UNITED STATES PATENT AND TRADEMARK OFFICE

APPLICATION NO.	FILING DATE	FIRST NAMED INVENTOR	ATTORNEY DOCKET NO.	CONFIRMATION NO.
10/679,697	10/07/2003	Choong Un Lee	054358-5017	3567

Office Action Summary

DETAILED ACTION

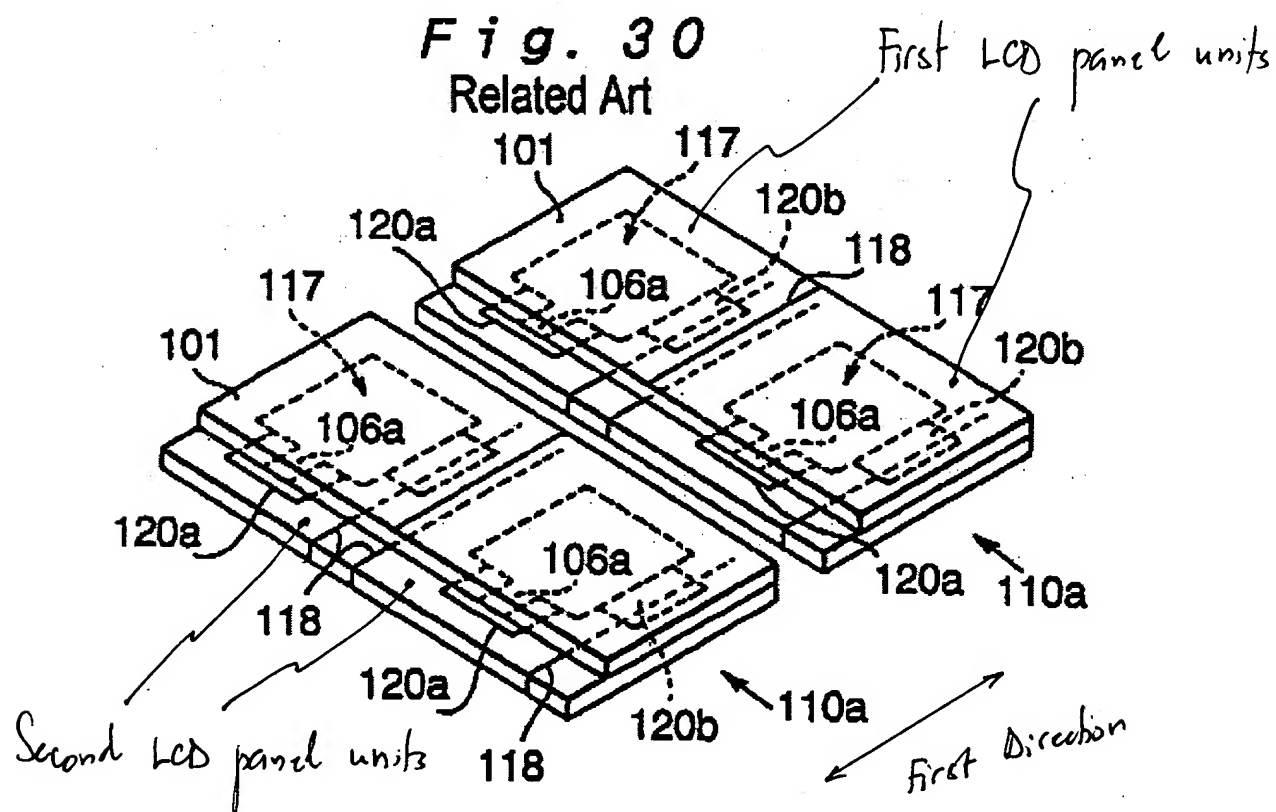
Re claim 1, as shown in Figs. 28-31 (Fig. 30 is annotated), Koder et al. discloses a method of fabricating a liquid crystal display (LCD) panel, comprising:

forming a plurality of upper LCD panel sections (in sealing-in areas 117) on a first mother substrate 101 and a plurality of LCD panel sections (in sealing-in areas 117) on a second mother substrate 104 (col. 1, lines 22-26);

forming sealant patterns 106 on at least one of the mother substrates 101 and 104 (col. 1, lines 26-28);

attaching the first and second mother substrates 101 and 104 to each other to bond the upper LCD panel sections with associated ones of the lower LCD panel

sections to form at least first and second LCD panel units 117 (Fig. 30 and col. 1, lines 28-32);

forming at least (first) cutting lines 108 and 118 on each of the first and second mother substrates 101 and 104 the (first) cutting lines 108 and 118 corresponding to a boundary of the first and second LCD units 117 (col. 1, lines 36-60); and

separating the first and second liquid crystal display panel units into individual LCD panels 119 (Fig. 31 and col. 1, lines 60-63).

It is noted that, as shown in Figs. 28 and 30, the cutting lines 108 and 118 create a plurality of dummy sections between the LCD panel units 117.

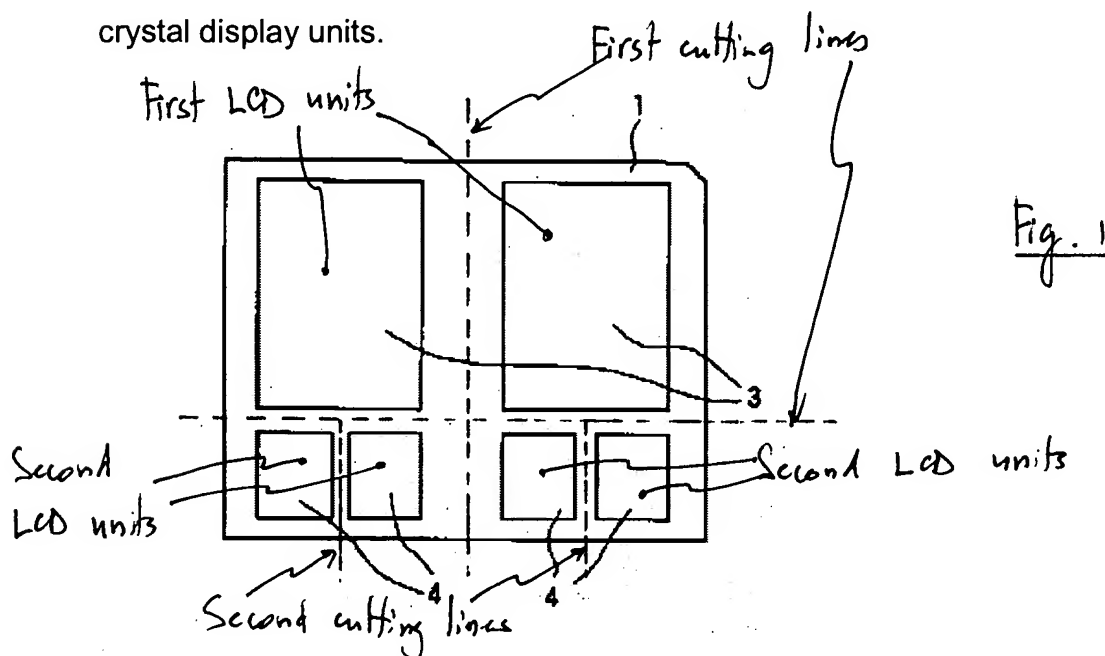
At first, as shown in Fig. 1 (annotated), Hakoda discloses a method of fabricating liquid crystal display panels comprising forming first liquid display panel units 3 and second liquid crystal display panel units 4 on a mother substrate 1, wherein the first liquid crystal display panel unit 3 is larger than the second crystal display panel unit 4 (Abstract and Detail Description, paragraphs 7-9).

Thus, it would have been obvious to one having ordinary skill in the art at the time the invention was made to modify the method of fabricating liquid crystal display panels of Koderá with the teaching of Hakoda by forming liquid crystal display panel units having at least two different sizes on mother substrates in order to reduce production cost (Abstract). It is also obvious that second cutting lines are definitely

required to separate the second liquid crystal display panel units into four individual TFT panels 4; accordingly, the second cutting lines are spanning only a portion of the first and second mother substrates and corresponding to a boundary of the second liquid crystal display units.

Also, Hakoda is employed for teaching a mother glass substrate 1 comprising a plurality of LCD panel sections having at least two different sizes for reducing the production cost as shown in Fig. 1, where the mother glass substrate is cut into LCD units 3 and 4 (see Abstract).

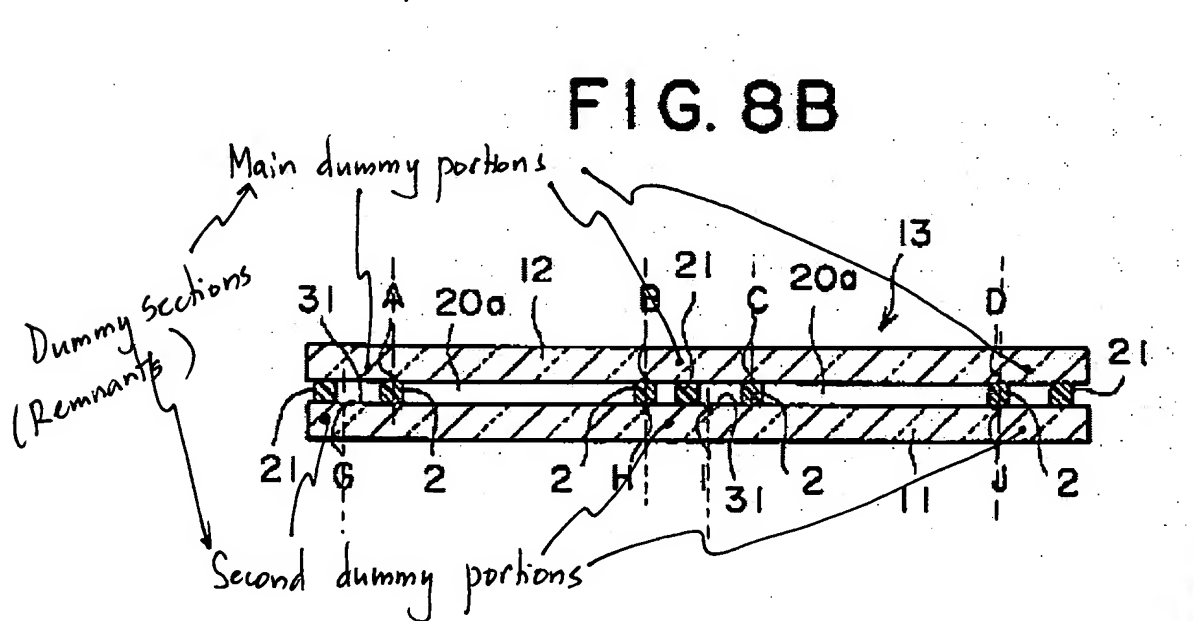
Further, as shown in Figs. 7A, 7B, 8A and 8B (Fig. 8B is annotated), Shiraishi discloses a method of fabricating a liquid crystal display panel, comprising:

forming cutting lines (scribe cracks) A-L on each adhesive surface of the first mother substrate and second mother substrates 11 and 12 (col. 8, lines 45-51), the cutting lines A-L corresponding to a boundary of the liquid crystal display panel unit 20a (Figs. 7A and 7B); note that the cutting lines A-D, G-J are formed substantially in the first direction (vertical direction in Fig. 8A) and spanned the entire width of the first and second mother substrates 11 and 12; and

wherein the cutting lines A-F extend over sealant pattern 2 (Figs. 8A and 8B);
and

wherein, as shown in the annotated Fig. 8B, the first and second mother substrates 11 and 12 include a plurality of dummy sections, each dummy section including main dummy portion and second dummy portion, and at least one of the sealant patterns 21 (dummy patterns) under the cutting lines A-F binds the main dummy portions and secondary dummy portions together during the separating step. Shiraishi discloses that the sealant pattern 21 is provided in order to prevent the bias of the stress when cutting the substrates (col. 10, lines 50-52).

Fig. 8B also shows that the main dummy portions and the secondary dummy portions are formed between the liquid crystal display panel units 20a.

Re claim 5, Shiraishi discloses that the sealant pattern 21 is positioned on both the main dummy glass substrates and the second dummy glass substrates as shown in Fig. 8B.

Re claims 6 and 11, Fig. 8B of Shiraishi shows that sizes of the upper liquid crystal display panel units on the first mother substrate 12 and the lower liquid crystal

The Examiner disagrees with Applicant's remarks since Fig. 8B (annotated) of Shiraishi clearly shows that the first and second mother substrates include a plurality of dummy sections, each dummy section including a main dummy portion and a secondary dummy portion.

The most relevant reference, US 6,864,947 B2 to Shiraishi, fails to disclose or suggest the remnants including main dummy portions and secondary dummy portions divided by the first cutting lines therebetween. As shown in Fig. 8B, Shiraishi discloses remnants including main dummy portions and secondary dummy portions separated from the mother substrates 11 and 12 respectively by the cutting lines A-D, G-J.

However, these cutting lines are not between the main dummy portions and the secondary dummy portions.
